Nvarchi Group Pty Ltd
Wembley, WA 6014

DA Ref No.: 5.2023.493.1

APPLICANT JUSTIFICATION

1. Street Setback (Victoria Park Dr)

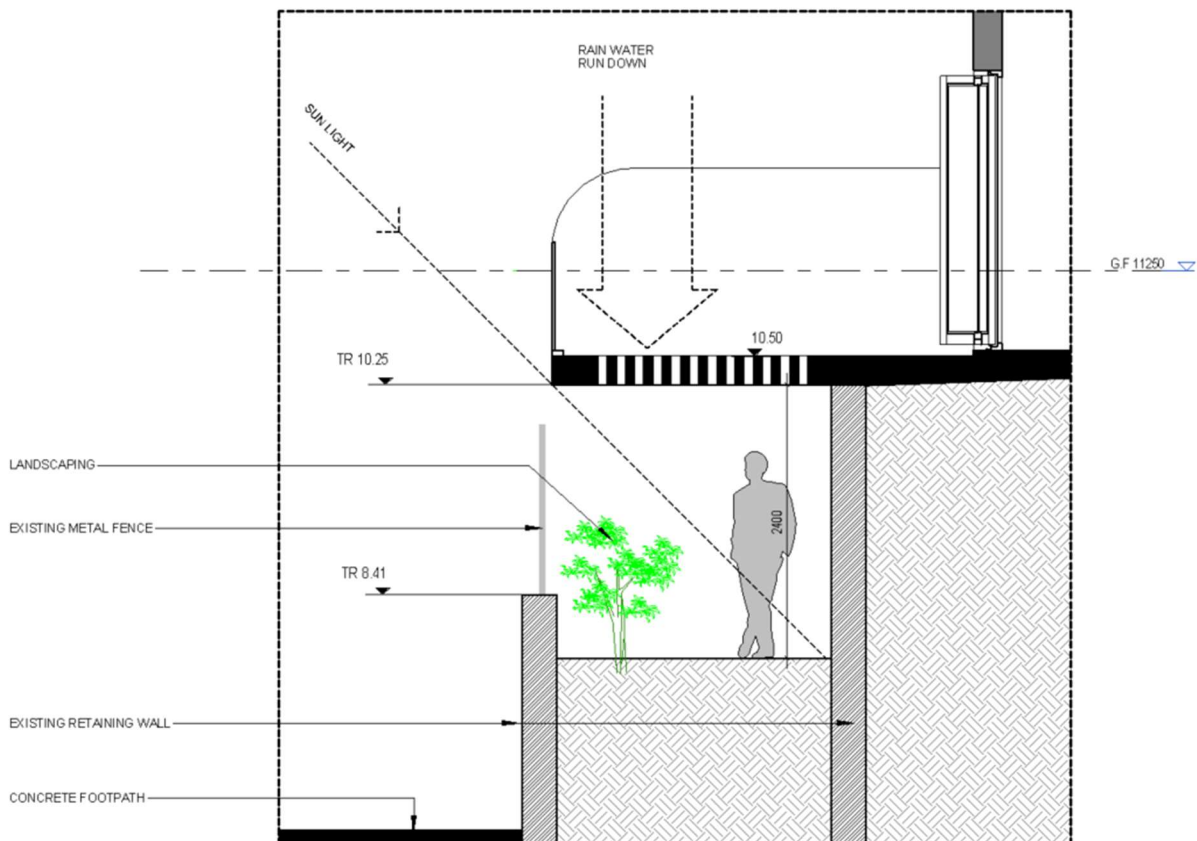
Issue: The proposed ground level is setback 0.2m to Victoria Park Drive in lieu of a minimum 1.5m, as identified at provision 6 of The Peninsula, Burswood - Local Development Plan No.1.

Justification: The cantilever structure is necessitated by the significant difference in ground levels and the presence of two large retaining walls. The rear courtyard space would be wasted without this design. By cantilevering from the top of the retaining wall, we create useful space that functions as a backyard rather than a building extension.

- **Practical Use:** The cantilevered area is used as a backyard, not as a building extension, which makes it functional and enhances the overall use of the space.
- **Removability:** The structure, made from steel frames and timber decking, is removable.
- **Environmental Integration:** The timber decking allows for natural landscaping, as it receives rainwater and sunlight through the gaps, maintaining the natural ecosystem.
- **Precedent:** Similar designs can be found on neighboring properties at Lot 169 and Lot 170, which have set a precedent for such structures.

2. Garage Setback (Bow River Crescent)

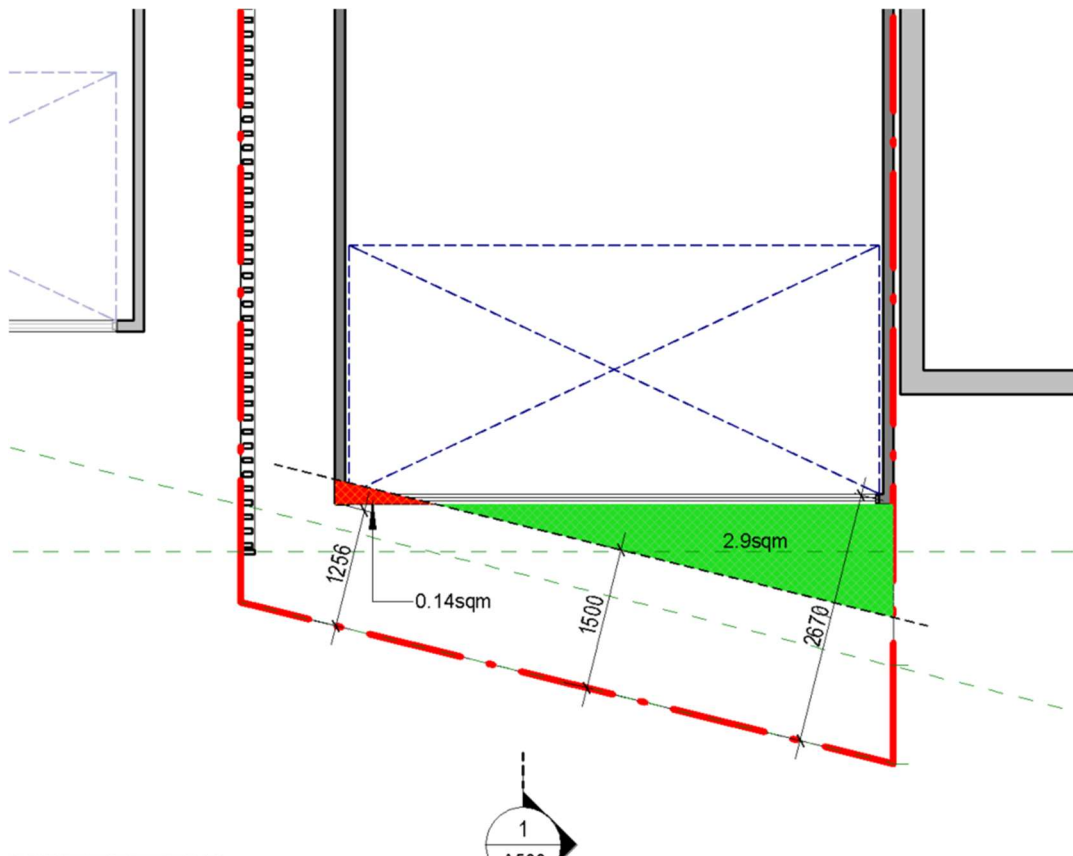
Issue: A portion of the proposed garage is setback 1.2m in lieu of a minimum 1.5m, as identified at provision 8 of The Peninsula, Burswood - Local Development Plan No.1.

- **Lot Shape:** The lot does not form a perfect square angle with the street, resulting in an angled garage.
- **Average Setback:** The east side of the garage has a setback of 1.256m, while the west side has a setback of 2.670m, averaging 1.963m. This gives the garage a reasonable setback appearance from the public realm.
- **Minimal Encroachment:** Only a very small portion (0.14 m²) of the garage encroaches into the 1.5m setback area, which is minimal compared to the overall green setback, maintaining a reasonable appearance from the public realm.
